DOE Gap Analysis Comments

Environmental Impact Statement – Draft Gap Analysis (Area IV SSFL EIS)

Task Order:DE-AT30-08CC60021/ET17

Draft Gap Analysis Report

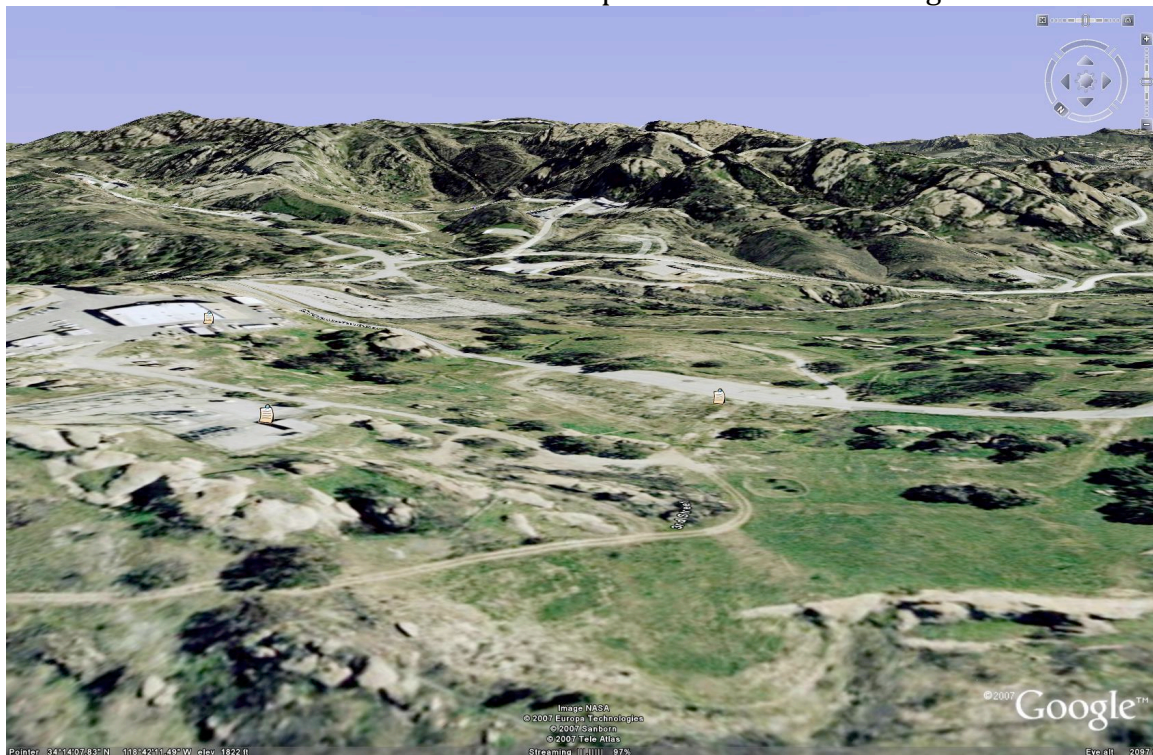
The lower portion and road leading to the left in the photograph shown below, of the Old Conservation Yard in Area IV, leads to RD56a and based on the rock formations on the lower right, the waste storage went far beyond the intended boundaries of the facility. This is also a very steep hillside leading down to the Brandeis Bardin Camp. Please note that RD56a is placed outside of Area IV.

The following photograph from GoogleEarth depicts the same area with those same rock-formations marked to indicate the steep terrain and off-site migration flow.

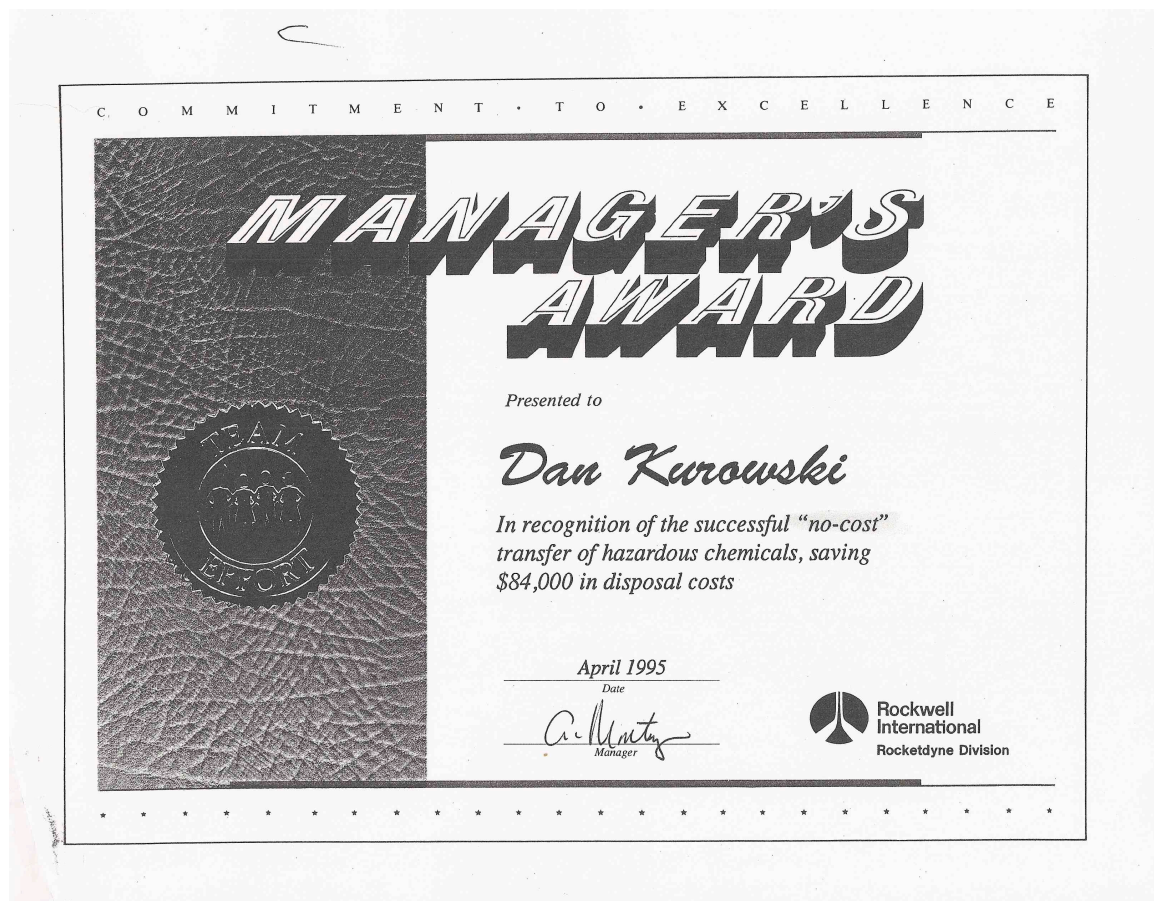
Historical photographs of the OCY were provided by Mr. Dan Kurowski through discussions with his widow (he was a former worker who spent many years at the SSFL).
